## DEPARTMENT OF TRANSPORTATION

### National Highway Traffic Safety Administration

### Federal Motor Vehicle Safety Standards; Platform Lifts for Motor Vehicles; Platform Lift Installations in Motor Vehicles

**ACTION:** Final rule.

**FIGURE 2**

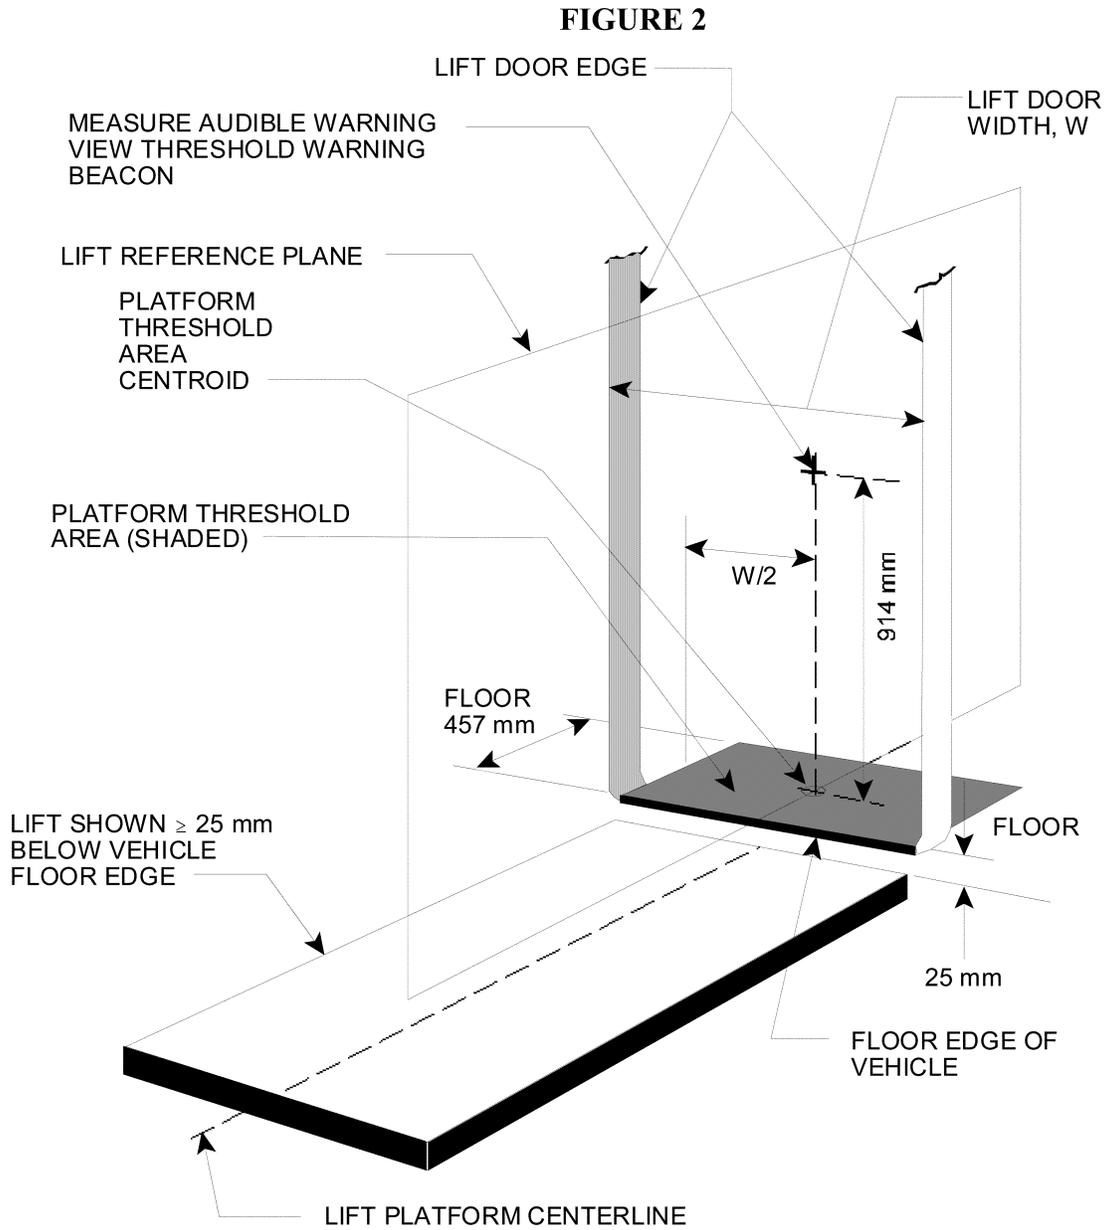
NHTSA also proposed a correction to Figure 2 of FMVSS No. 403. Currently, the height of the measurement point from which the intensity of the threshold audible warning is measured is identified as 919 mm. The proposed amendment would replace that distance with the correct measurement point of 914 mm (3 feet).

candela, a frequency from 1 to 2 Hz, and must be located within the interior of the vehicle such that it is visible from a point 914 mm (3 ft) above the center of the threshold area (see Figure 2) wherever the lift is installed and with any configuration of the vehicle interior.

\* \* \* \* \*  
S6.1.6 The intensity of the audible warning and visibility of the visual warning required by S6.1.2 and S6.1.3 is measured/observed at a location 914 mm (3 ft) above the center of the platform threshold area. (See Figure 2).
